| <b>SPRING CREEK FOREST<br/>   PRELIMINARY OVERALL AREA DEVELOPMENT PLAN</b>                                     |                           |   |

RE: Spring Creek Forest POADP, Plan #91

Re: Spring Creek Forest P.O.A.D.P. (Revised)

Reference is made to the Preliminary Overall Area Development Plan (POADP) for Spring Creek Forest (File #83-19-63-64) submitted for staff's review. Said plan was jointly reviewed by Planning and Traffic Engineering staff. Our review was concentrated on areas for which plats have not been approved or recorded.

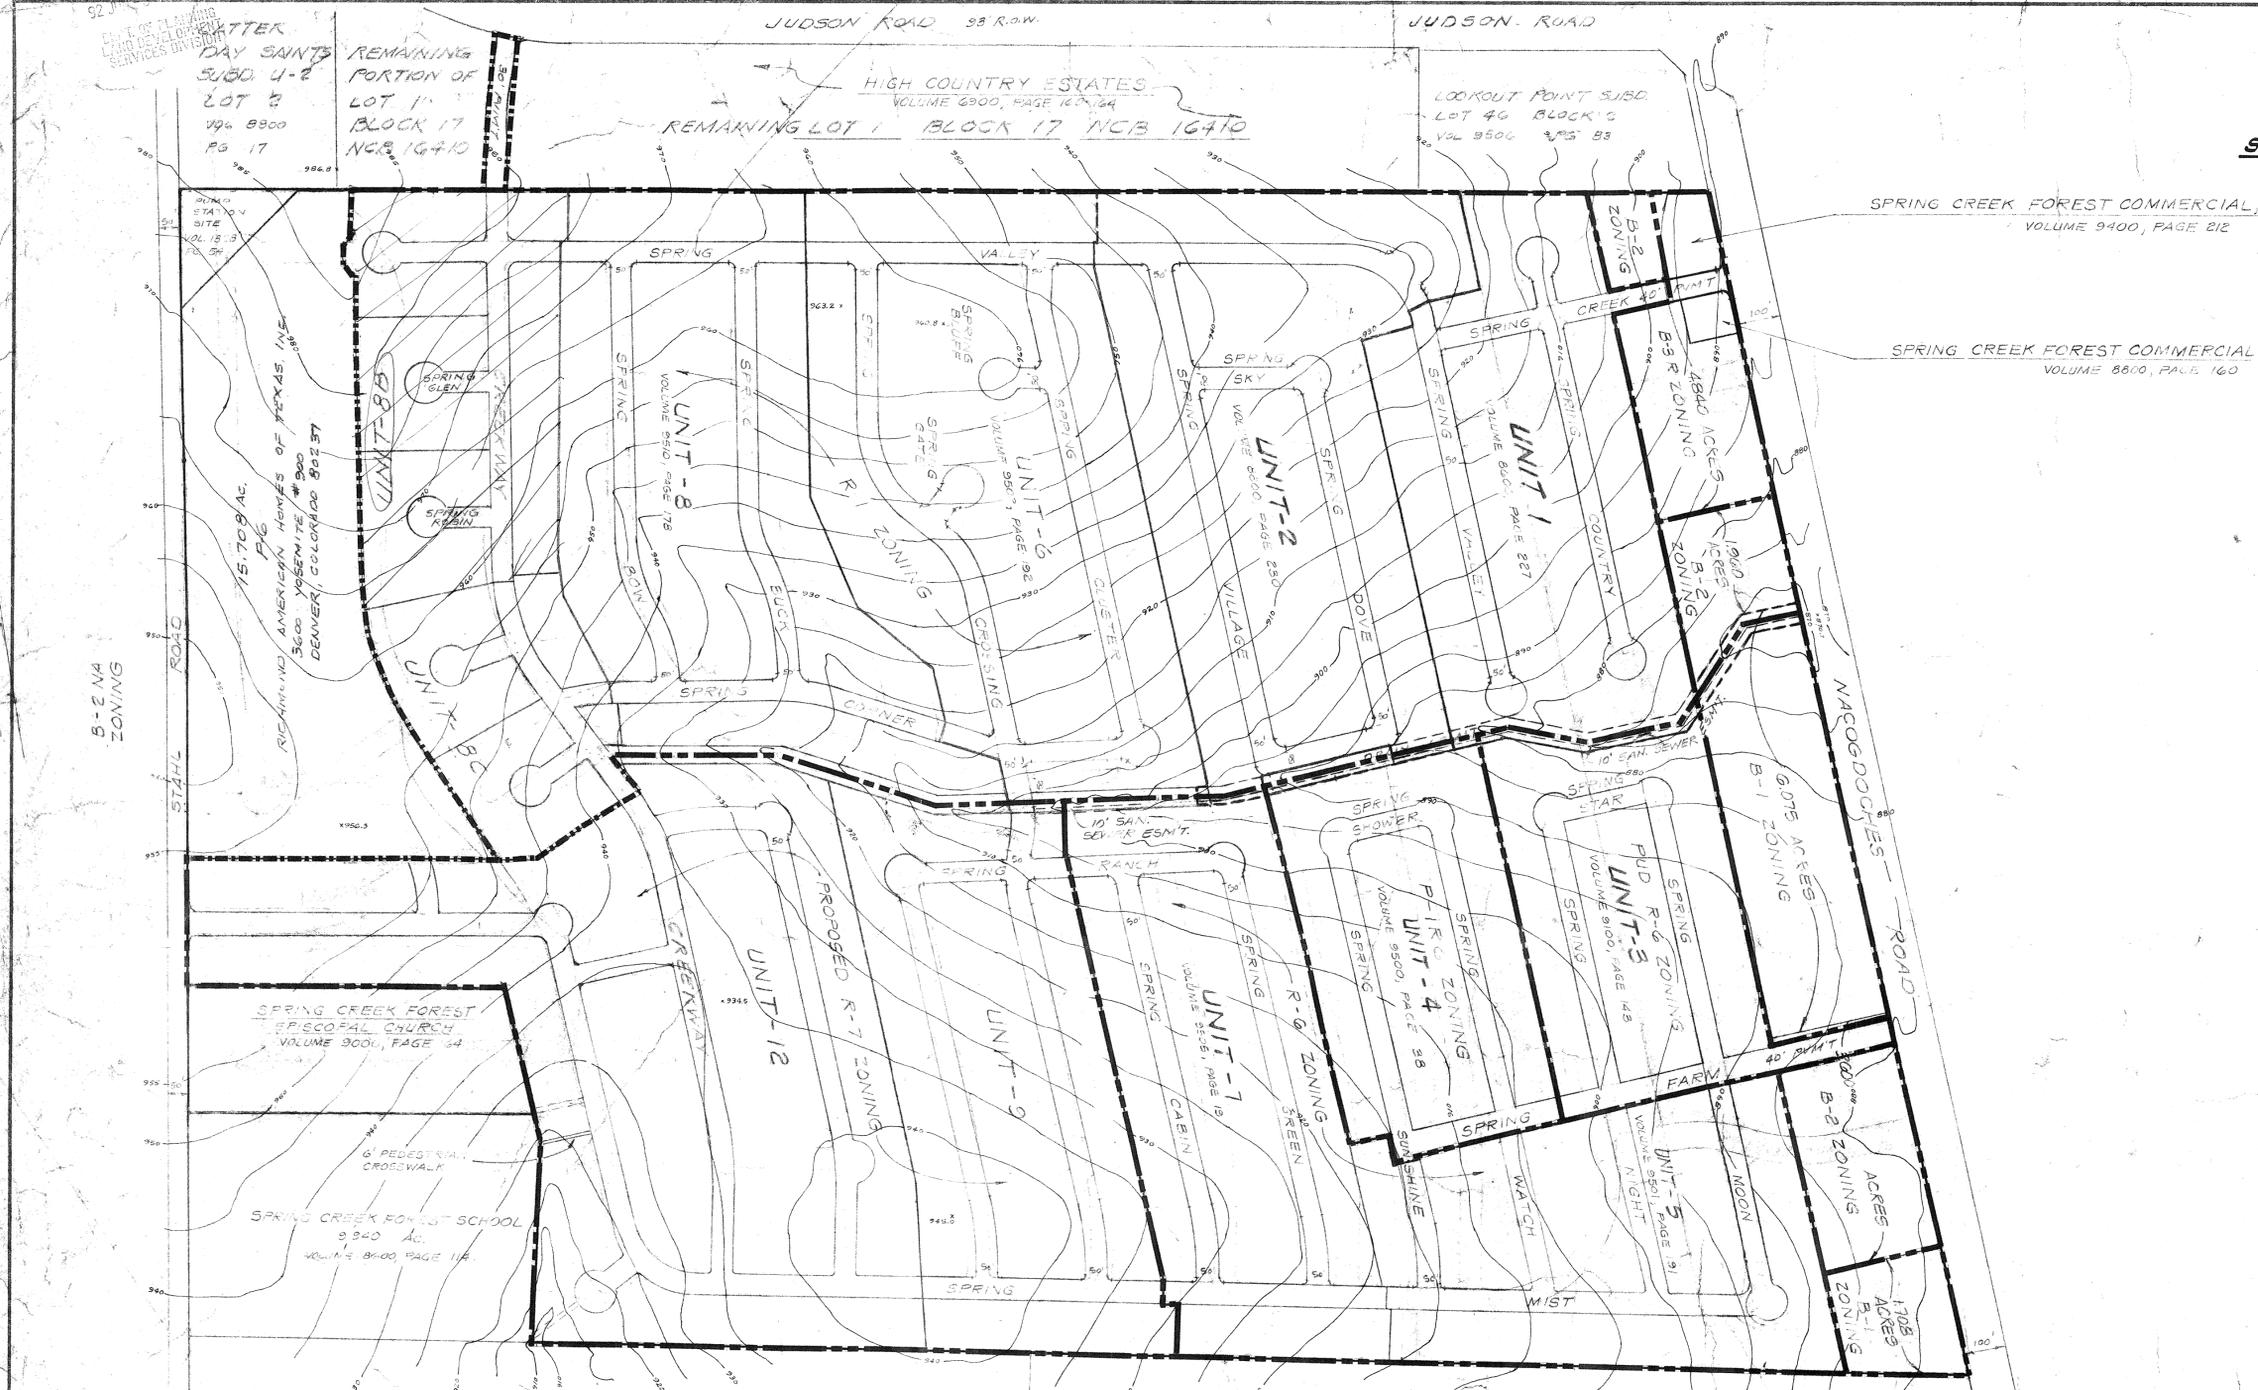
The Development Review Committee has reviewed and accepted your revised plan.

| DATE  | NO. | REVISION DESCRIPTION  | BY                |
|---|-----|---|-------------------|
| <b>SPRING CREEK FOREST<br/>PRELIMINARY OVERALL AREA DEVELOPMENT PLAN</b>  |     |   |                   |

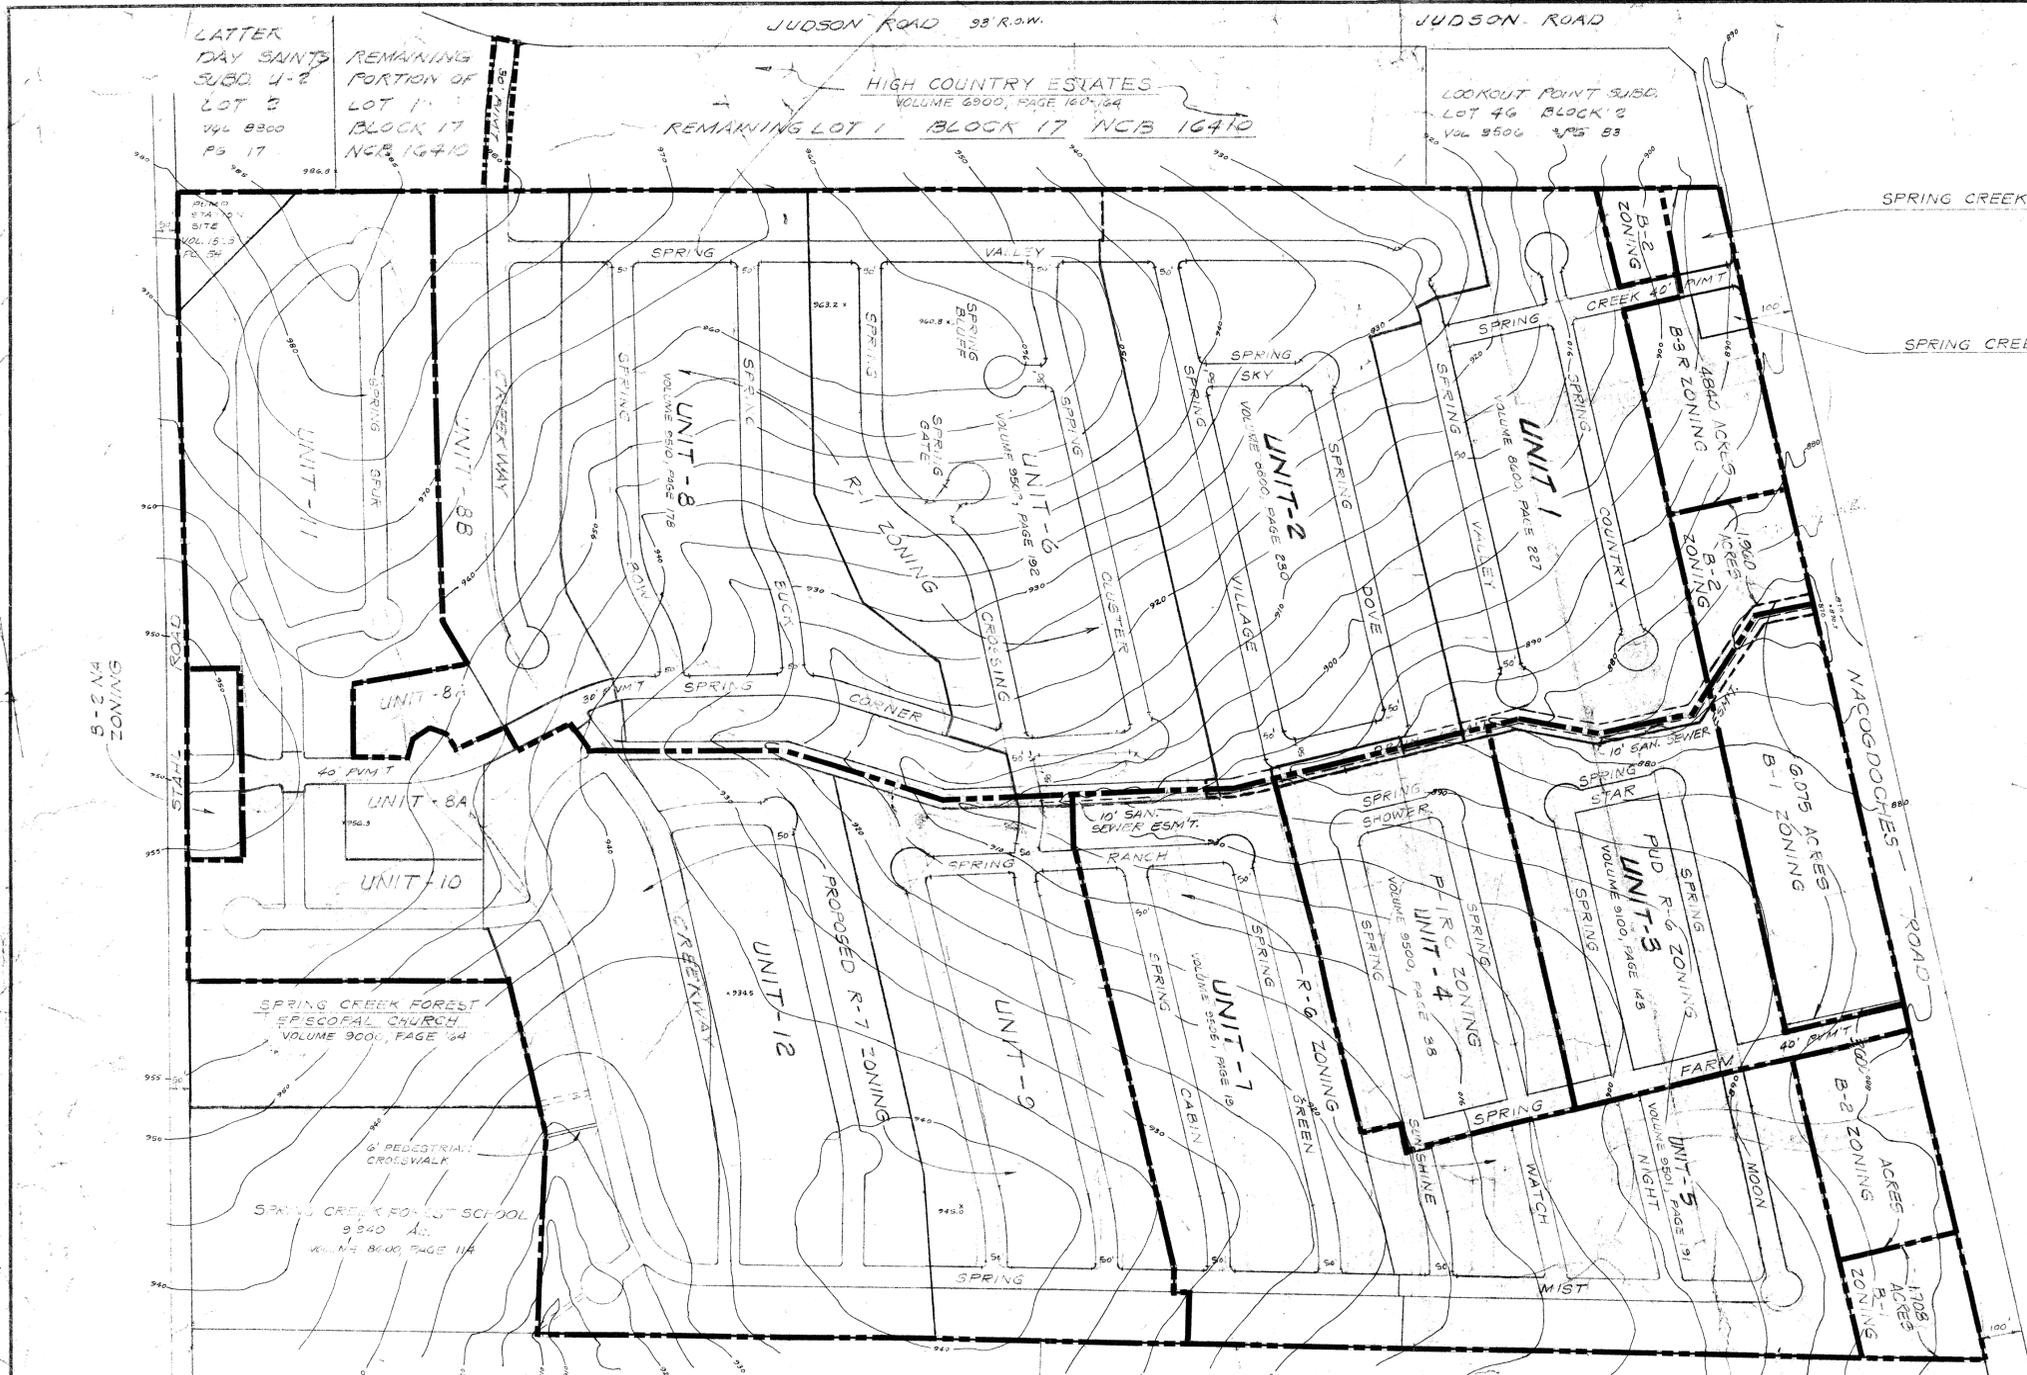
Staff notes that Stahl Road is on the Major Thoroughfare Plan as a Secondary Arterial 86' foot Right-of-way. Future platting along this thoroughfare will require street dedication.

The Committee concurs in the proposed extension of Creekway Drive to Judson Road. However, this connection will encourage cut through traffic for vehicles making a right turn from Stahl Road to Judson. This problem was raised by David Abbey, City Traffic Engineer, during a meeting with Roger Bose, Dan Kossel, Eddie Guzman, and myself. The Committee strongly recommends that you consider revising the street layout to avoid a direct connection from Stahl to Judson via Spring Corner and Creekway.
